Addendum No. 1 Bid No.030823-MLK Cold Box Addition

ADDENDUM NO. #1 Bid No.030823-MLK Cold
Box Addition

PROJECT: Martin Luther King Jr. Middle School
Cold Box Addition

JOB NO.: 21182
DSA File No.: 20-30
DSA App. No.: 02-120015

3. Drawing, Sheet E1.04, Panel Schedule

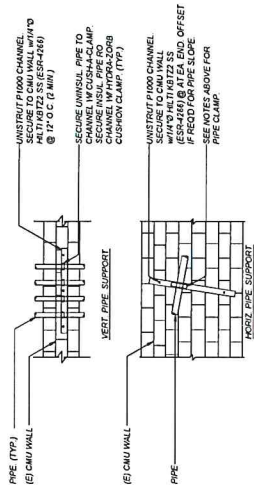
- a. Revised mechanical Equipment schedule.
- b. Revised voltage drop calculations.
- c. Revised Panel WF schedule.

SHEET
PROJECT: 11542
TITLE: MECHANICAL
DETAILS &
SCHEDULES

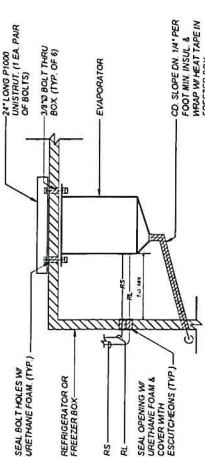
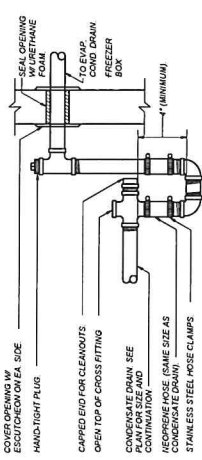
2. Drawing, Sheet MP-2, Mechanical Details & Schedules:

- a. Evaporator Schedule:
 - i. Revised evaporator E-1 Full Load Amps to 14.3 A.
 - ii. Revised model number of E-1 to "E1LD0142B-TE2".
 - iii. Revised evaporator E-2 Full Load Amps to 2.4 A.
 - iv. Revised evaporator E-2 voltage to 115-volt single phase.
 - v. Revised model number of E-2 to "E1MD0163A-TA2".
 - vi. Revised weights of E-1 and E-2 to 78 lbs. and 72 lbs., respectively to match Structural Calculations.
- b. Condensing Unit Schedule:
 - i. Revised condensing unit CU-1 model number to "MSLD040AB".
 - ii. Added MCA / MOP requirements for CU-1 and CU-2:
 - 1. CU-1: MCA = 48 A, MOP = 60 A
 - 2. CU-2: MCA = 31 A, MOP = 35 A
 - iii. Added refrigerant piping connections for CU-1 and CU-2:
 - 1. Liquid line size = 1/2"
 - 2. Suction line size = 7/8"
 - iv. Revised condensing unit CU-2 model number to "MSMD020AB".

SHEET: **E3.01**
PROJECT: 21182

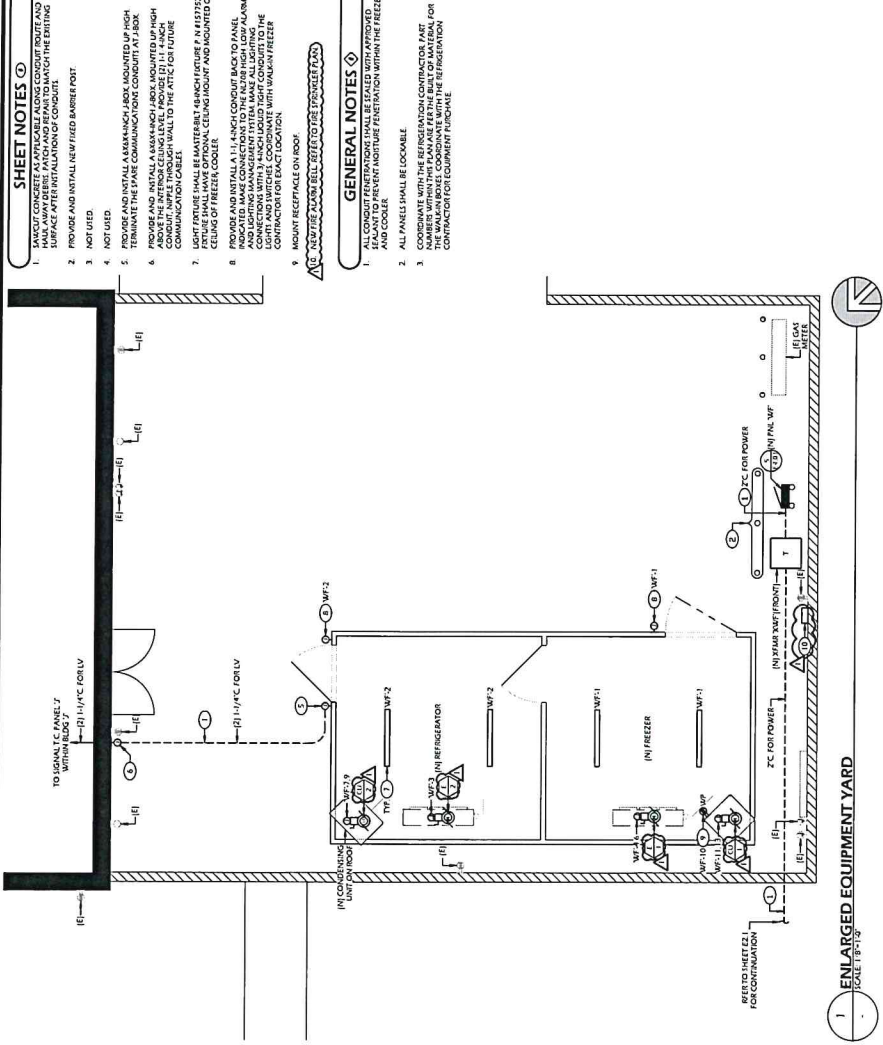
4. Drawing, Sheet E3.01, Enlarged Equipment Yard

- a. Revised Evaporator and Condenser unit labels.
- b. Revised Keynote 10: New Fire Alarm bell.
